Moore'sCloud Holiday

Title			
Moore'sCloud Holiday - Aux CPU & I/O			
Size	Number	Revision	
A4	*	2a	
Date:	6/09/2013	Sheet 2 of	2
File:	\\.\Holiday Aux r2a.SchDoc	Drawn By:	KJM

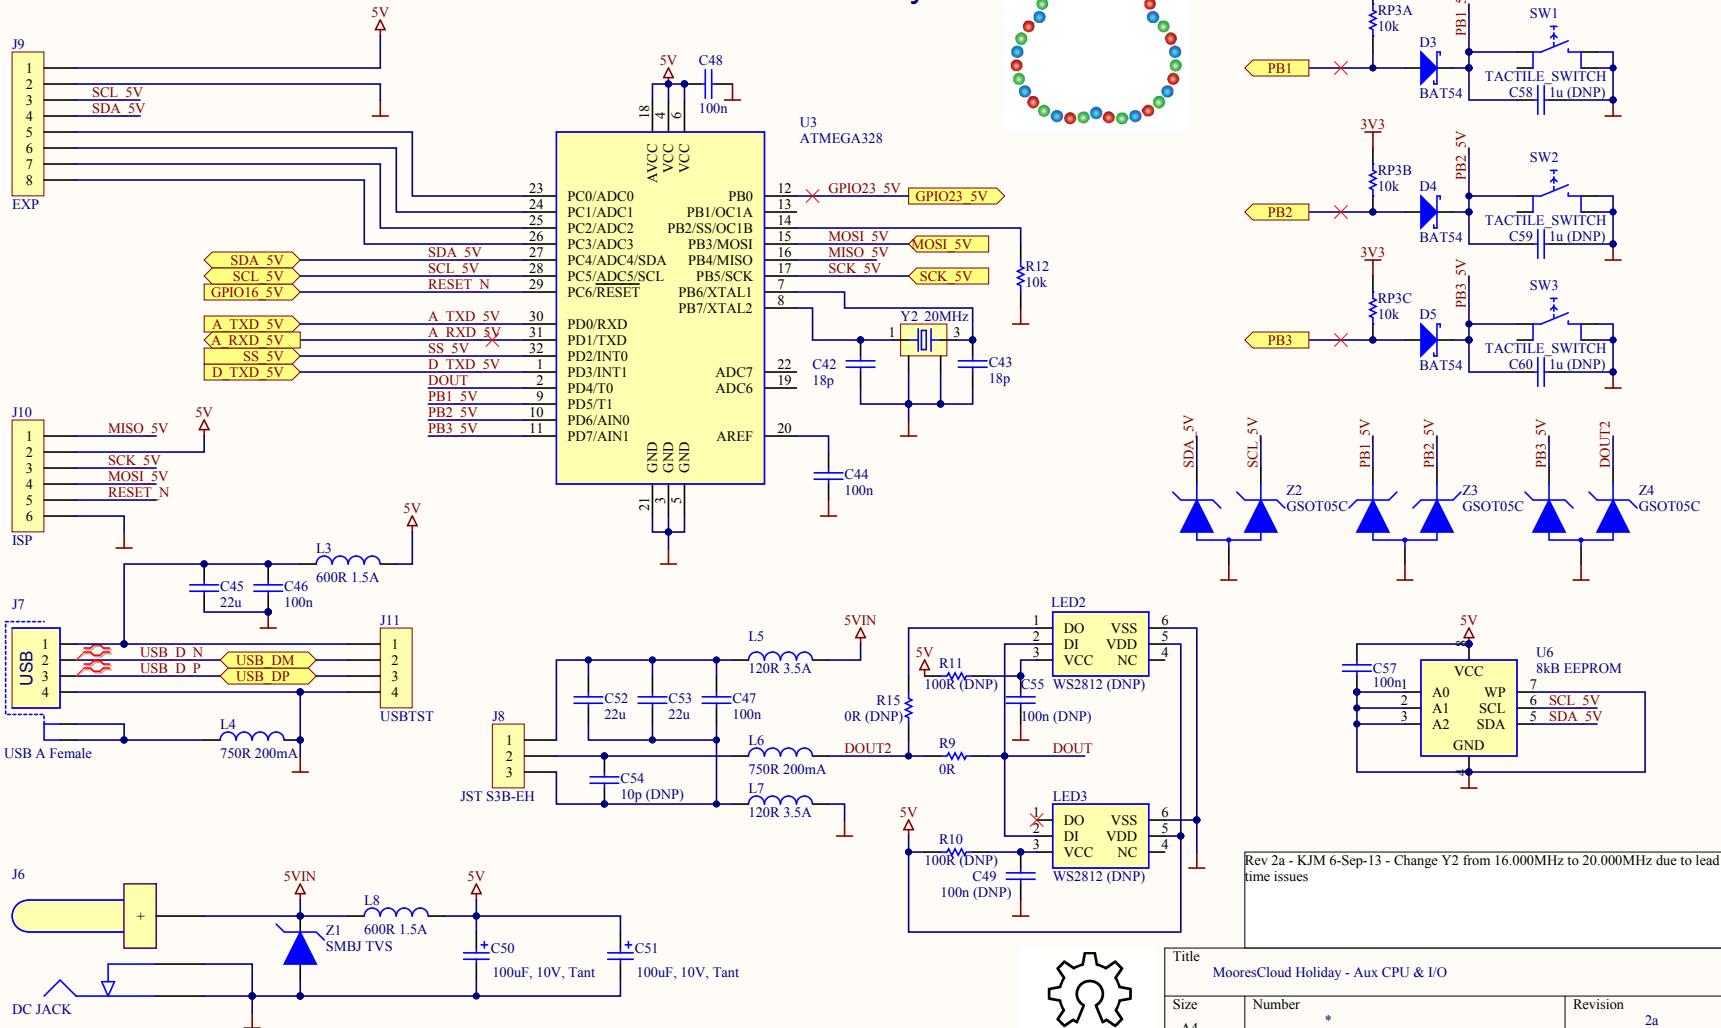
Rev 2a - KJM 6-Sep-13 - Change Y2 from 16.000MHz to 20.000MHz due to lead time issues
